summary of changes between
BS 8243 and DD 243:2004
– a guide

May 2010

SUMMARY OF THE CHANGES BETWEEN BS 8243 AND DD 243:2004

A.1 Entry timeout after expiry of minimum 30 seconds operation indicator or WD

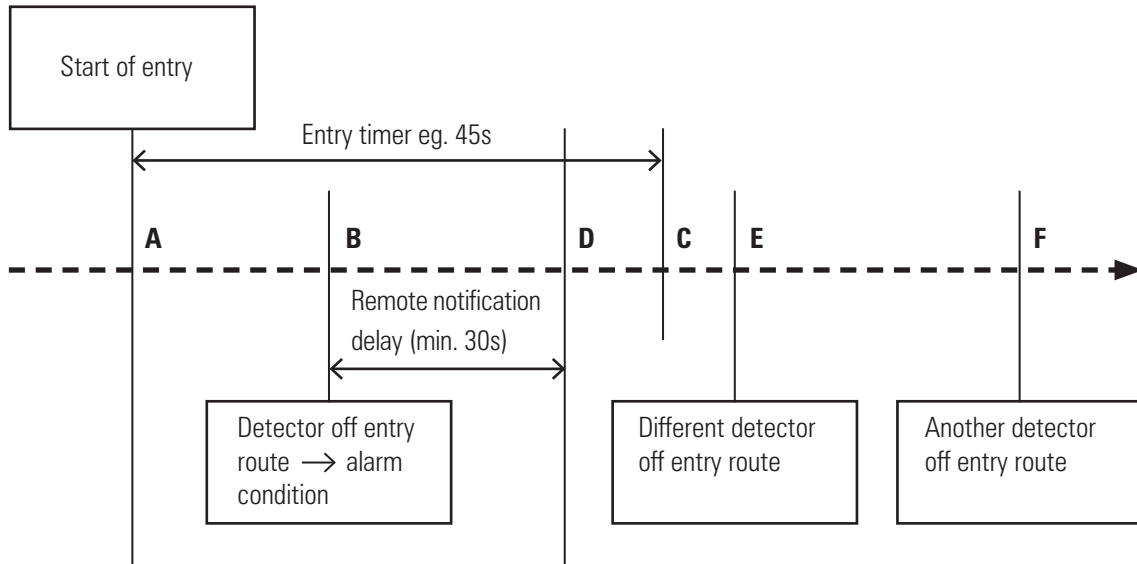
A.1.1 DD 243:2004 current Operation

Key	Action
A	Entry timer starts
B	Alarm notified locally by WD or indicated Minimum 30s delay starts
D	No action as entry timer in A above still active
C	Unconfirmed alarm condition notified remotely
E	No further action
F	Confirmed alarm condition notified remotely

A.1.2 BS 8243 Operation (refer to BS8243 fig. G.2)

Key	Action
A	Entry timer starts
B	Alarm notified locally by WD or indicated. Minimum 30 seconds delay starts
D	No action as entry timer is still active
C	Unconfirmed and confirmed alarm conditions notified remotely
E, F	Confirmed alarm already notified – further detections can optionally be notified
